SUBJECT: SPECIAL SERVICE CAMPAIGN - Y04
(2000 MODEL YEAR ECHO BRAKE VACUUM PORT - COLD STATES ONLY)

SUBJECT: SPECIAL SERVICE CAMPAIGN – Y04
(2000 MODEL YEAR ECHO VACUUM BRAKE TUBE – COLD STATES ONLY)

TECHNICAL INSTRUCTIONS
FOR
SPECIAL SERVICE CAMPAIGN Y04
2000 ECHO
AIR TUBE
(19 Cold States Only)

2. DISCONNECT PVC HOSE

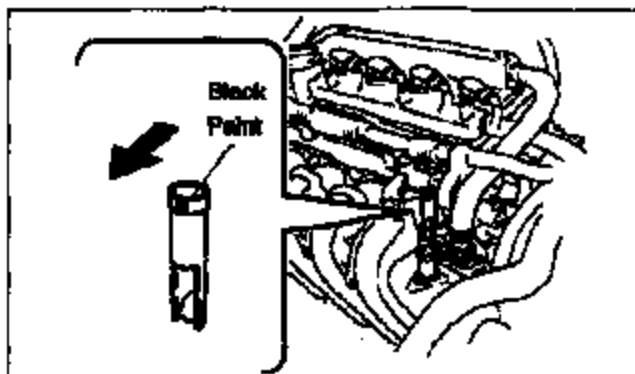
- Remove the clip holding the PCV hose to the intake manifold.
- Remove the PCV hose from the intake manifold.

4. REINSTALL THE PCV HOSE

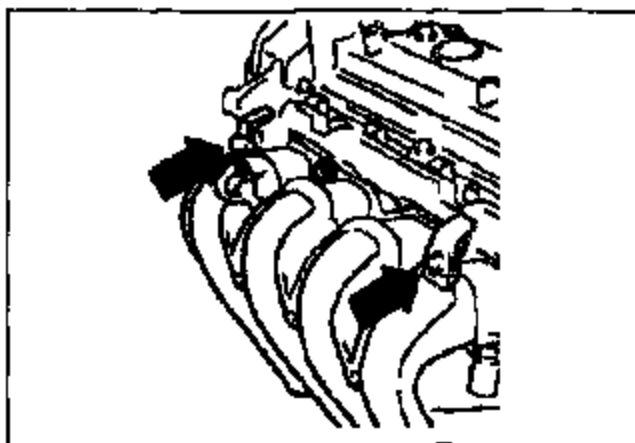
- Install the air tube into the PVC port so that the black paint mark is facing the radiator cap.

- Reinstall the PCV hose to the Intake manifold port.
- Reinstall the clip holding the PCV hose the intake manifold.

5. REINSTALL THE NO. 2 CYLINDER HEAD COVER

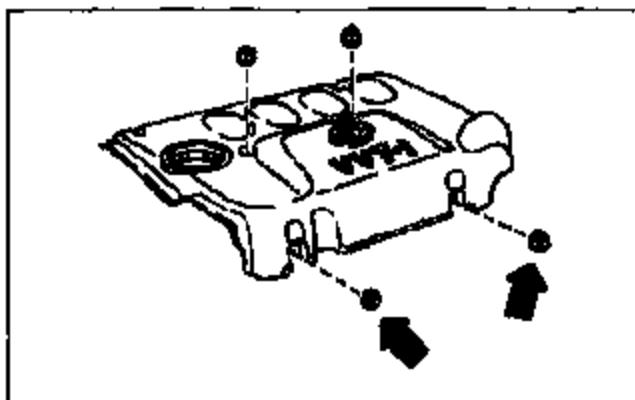
- (a) Torque the 2 intake manifold stud bolts.
TORQUE: 11 N•m(112 kgf•cm, 8 ft•lbf)

- (b) Reinstall the No. 2 cylinder head cover with the 4 cap nuts.
TORQUE: 7.0 N•m(71 kgf•cm, 62 In•lbf)
